PLANNING, ZONING, & BUILDING DEPARTMENT
PZ&B Staff Memorandum: Landmarks Preservation Commission

SUBJECT: HSB-22-017 (ZON-23-005) 128 SEABREEZE AVE (COMBO)

MEETING: FEBRUARY 17, 2023

The applicant has submitted plans “128 SEABREEZE RENOVATION” as prepared by LaBerge & Menard, Inc., dated January 12, 2023.

Figure 2: Variance Diagram

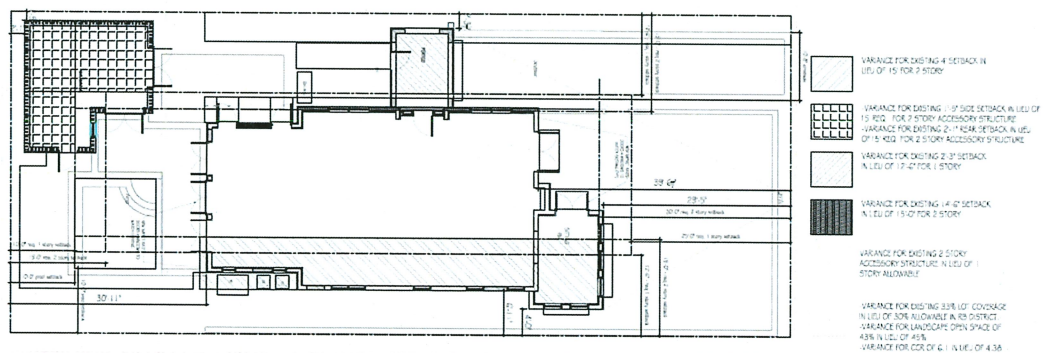
- Variance 1: Sec. 134-893(b)(13) a.1.: A variance for a Cubic Content Ratio of 6.1 in lieu of the 4.38 maximum Cubic Content Ratio allowed in the RB zoning district.

- Variance 2: Sec. 134-893(b)(11) b.: A variance for a lot coverage amount of 33% in lieu of the 30% maximum lot coverage allowed in the RB zoning district.

- Variance 3: Sec.134-893(b)(12) a.: A variance for landscape open space of 43% in lieu of the 45% minimum landscape open space required in the RB zoning district.

- Variance 4: Sec. 134-891(b): A variance for a 2-story unattached accessory structure in lieu of the 1 story unattached accessory structure permitted for a lot under 20,000 square feet.

- Variance 5: Sec. 134-893(b)(7) a.: A variance for a reduced one-story west side yard setback of 2'-3½" in lieu of the 12'-6" required for the one-story portion of the primary residence.

- Variance 6: Sec. 134-893(b)(7) b.: A variance for a reduced two-story west side yard setback of 14.6' in lieu of the 15' required for the two-story portion of the primary residence.

- Variance 7: Sec. 134-893(b)(7) b.: A variance for a reduced east side yard setback of 4' in lieu of the 15' required for the two-story residence.

- Variance 8: Sec. 134-893(b)(7) b.: A variance for a reduced west side yard setback of 1'-5" in lieu of the 15' required for a two-story accessory structure.

- Variance 9: Sec. 134-893(b)(9) b.: A variance for a reduced rear yard setback of 2'-1" in lieu of the 15' required for a two-story accessory structure.
